RE-EVALUATION FORM

A. Re-evaluation Type(s): Design Change

Project Name: SR 5 (US 17/MAIN ST) FROM NEW BERLIN ROAD TO PECAN PARK ROAD

The purpose of this re-evaluation is to assess the impacts due to design changes in the typical section and the proposed stormwater pond sites.

Figure 2: PD&E Concept Typical Section

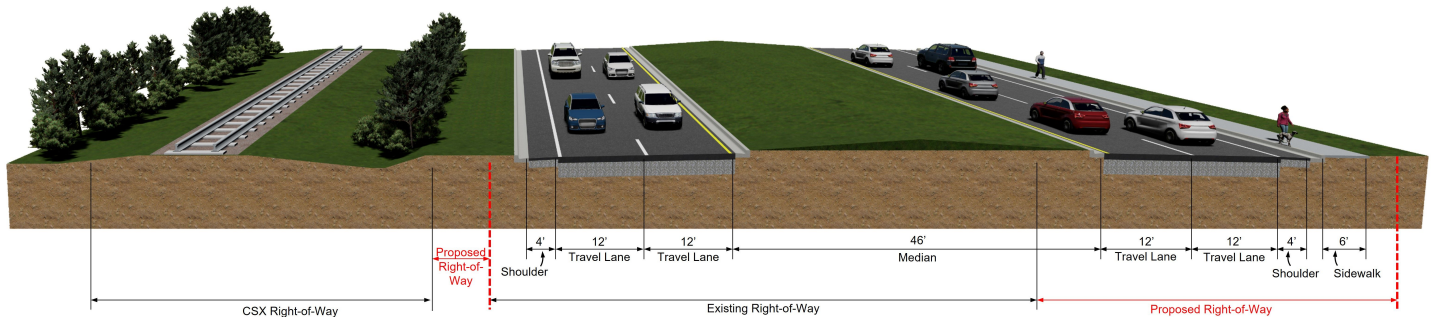
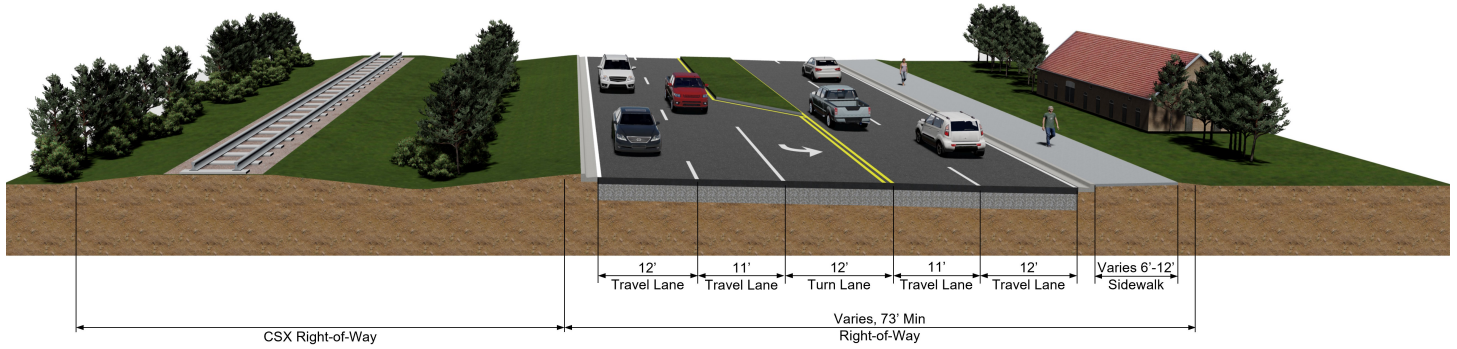
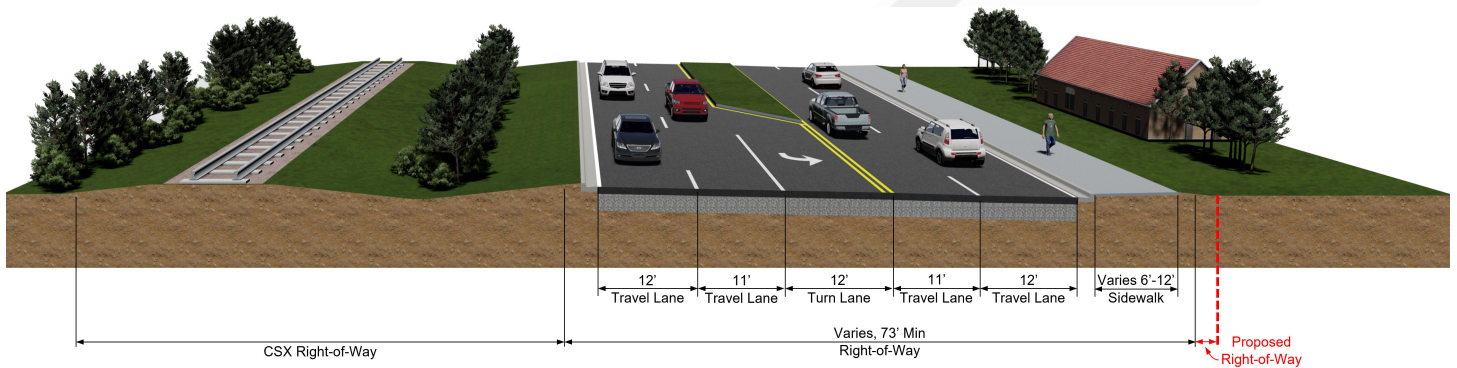
The Preferred Alternative typical section consisted of four 12-foot travel lanes, a 46-foot median and four-foot bike lanes as well as a six-foot sidewalk on the east side of US 17. No sidewalk was proposed on the west side due to proximity to the CSX railroad (see **Figure 2**). The right-of-way of the proposed PD&E typical section varies throughout the project with a minimum of 130 feet.

The Design Concept typical section consists of two 11 to 12-foot travel lanes, a center 10 to 12-foot turn lane, and a 6 to 12-foot sidewalk on the east side. No additional right-of-way is needed from New Berlin Road to Airport Center Drive. Additional right-of-way is needed from Airport Center Drive to Max Leggett Parkway/Duval Station Road for a turn lane and two stormwater ponds.

Figure 3 shows the Design Typical Section on US 17 from New Berlin Road to Airport Center Drive. **Figure 4** shows the Design Typical Section on US 17 from Airport Center Drive to Max Leggett Parkway.

Therefore, the typical section for the proposed widening was changed during the Design phase. The Design Concept replaced the 46-foot median with a single 10 to 12-foot turn lane.
